L190-E980566-00.D

NEXT ASSEMBLY NO. _____
 CUSTOMER DRAWING NO. D972001
 DRAWING TITLE BSC TOP ASSY
 REVISION: FROM OI TO A

HYTEC
INCORPORATED

DESCRIPTION OF CHANGE (Simple Phrase. Identify Dims if Possible):

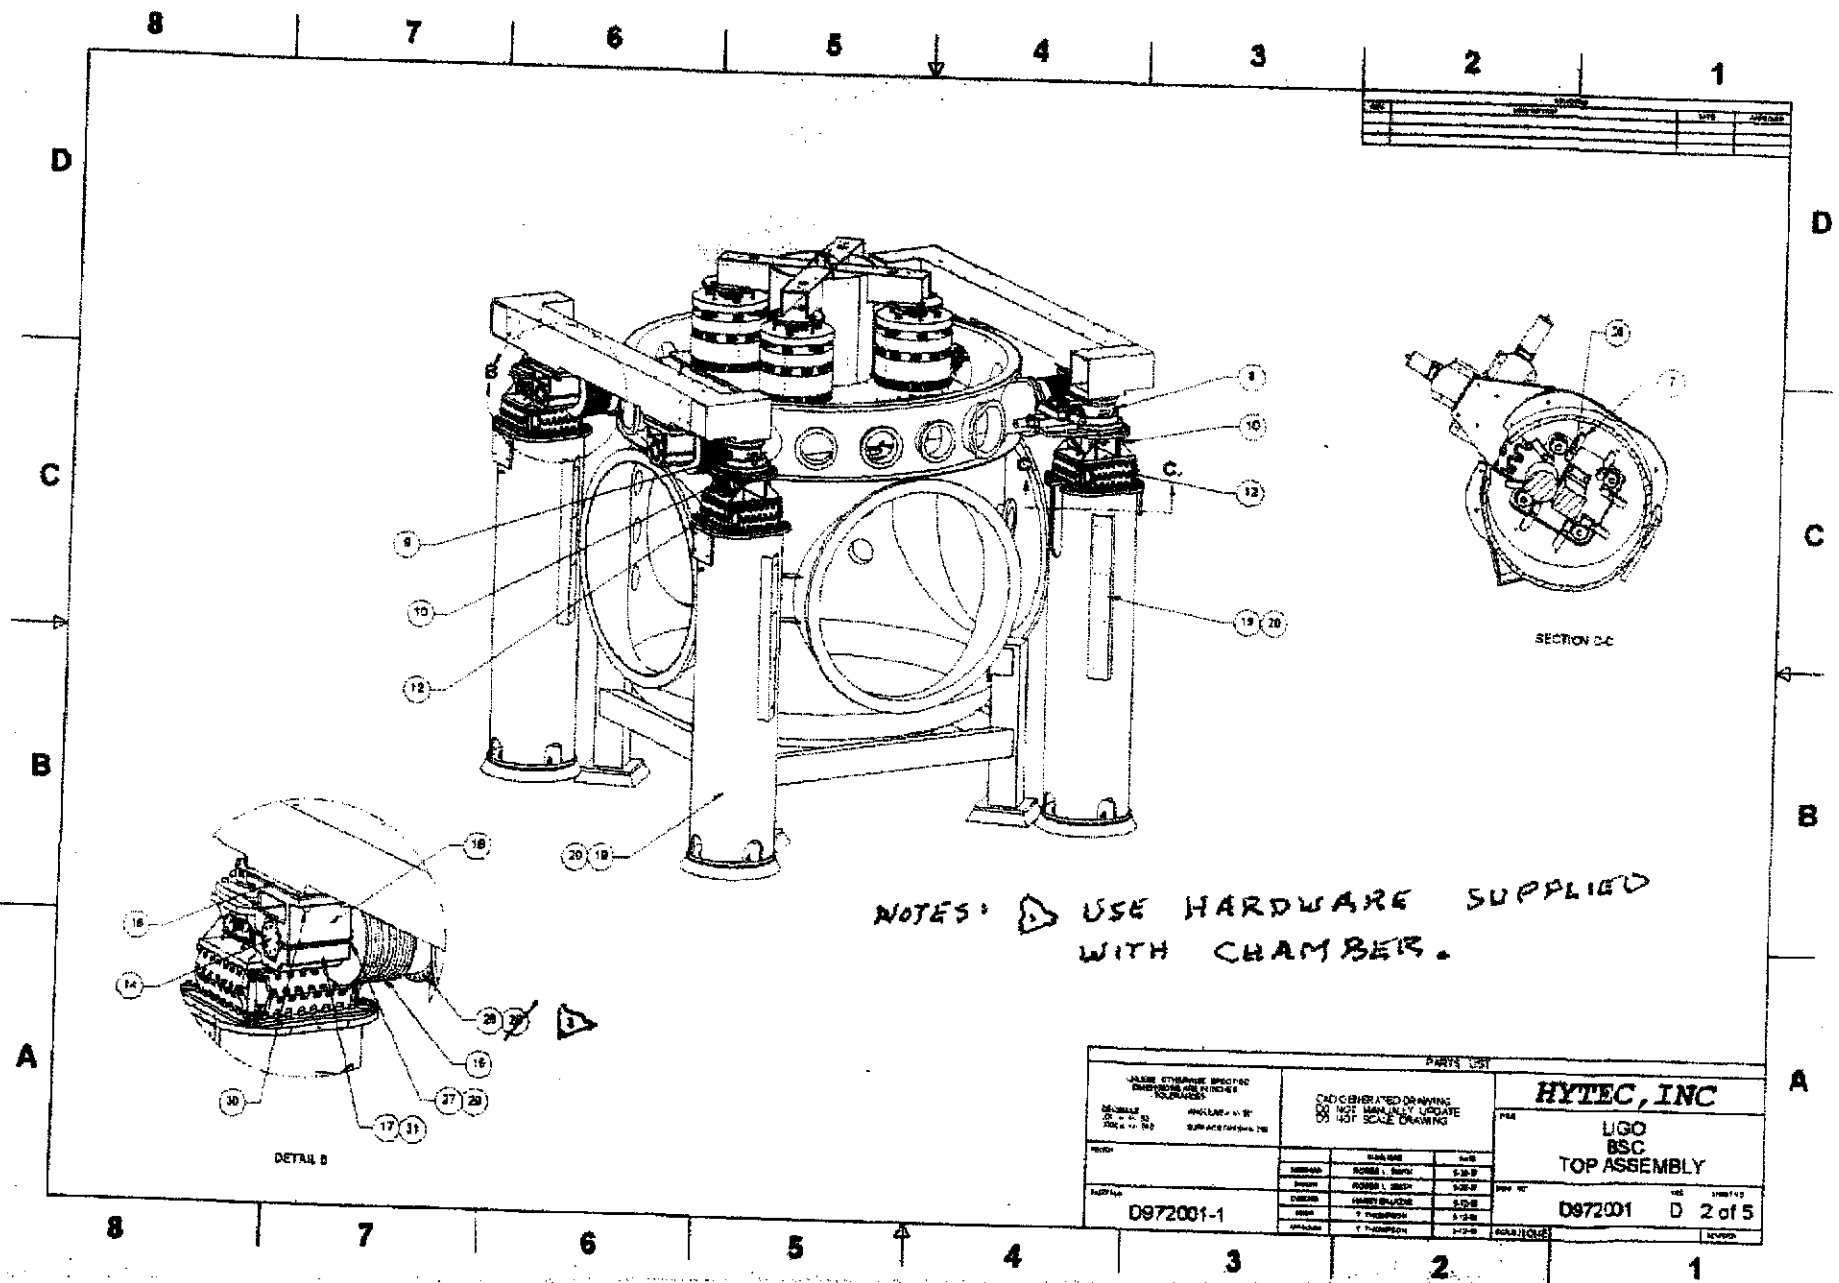
QTY = 48
 ① Change Item 30 to 4" LG. ② Item 25 to be 2.0 LG. ③ Delete item 28. Add note to use hardware supplied with vacuum chamber ④ add spherical bearing between crossbeam + air bearing ⑤ Item 24 to be 3" LG.
 ⑥ Screws from air bearing to Form X to be 1/2-20x1.75 ⑦ ADD heavy duty washer to hold adapter plate clamp Barnhill PN 318-12-A-01 or equiv.

①②④⑤⑥ Correct Eng ③ Reduce cost ⑦ Reduce deflection of adapter plate clamp.
